IMPORTANT SAFETY RECALL

NHTSA Recall No. 16V-234

Strick Trailers, LLC ("Strick Trailers") has decided that a certain dry freight van trailer, model number S4280E99NSWO, identified on the enclosed spreadsheet, fails to conform to Federal Motor Vehicle Safety Standard No. 223 "Rear Impact Guards".

STRICK TRAILERS, LLC #706641 / REAR IMPACT GUARD FIELD RETROFIT INSTRUCTIONS:

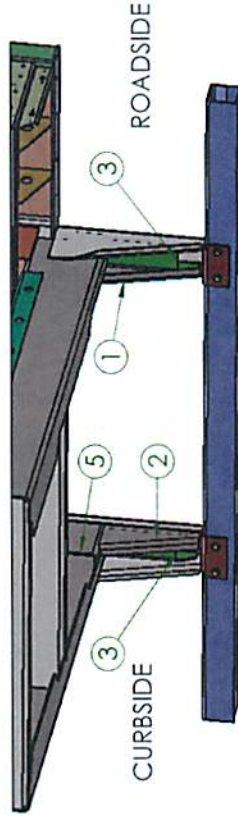
The noncompliance is in regards to the curbside and roadside rear impact guard gussets. Strick Trailers identifies the gussets with the numbers 55997 and 55998. These gussets do not meet the requirements of Federal Motor Vehicle Safety Standard 223 pertaining to rear impact guards. This could increase the risk of injury in the event of a rear impact crash.

CURRENT DESIGN

NEW DESIGN

In order to remedy the noncompliance, it will be necessary to reinforce the curbside and roadside rear impact guard gussets in accordance with the instructions (Drawing 706641) attached to this letter. We will supply the new reinforcement parts without cost and will ship them to multiple locations at your request. The parts necessary to reinforce the gussets are expected to be available for delivery beginning on June 26, 2016. We will also reimburse you for the reasonable direct labor costs involved in effecting the repair or will have the repair facilities bill us directly. The work to reinforce the rear impact guard gussets will take approximately two and one half hours to perform.
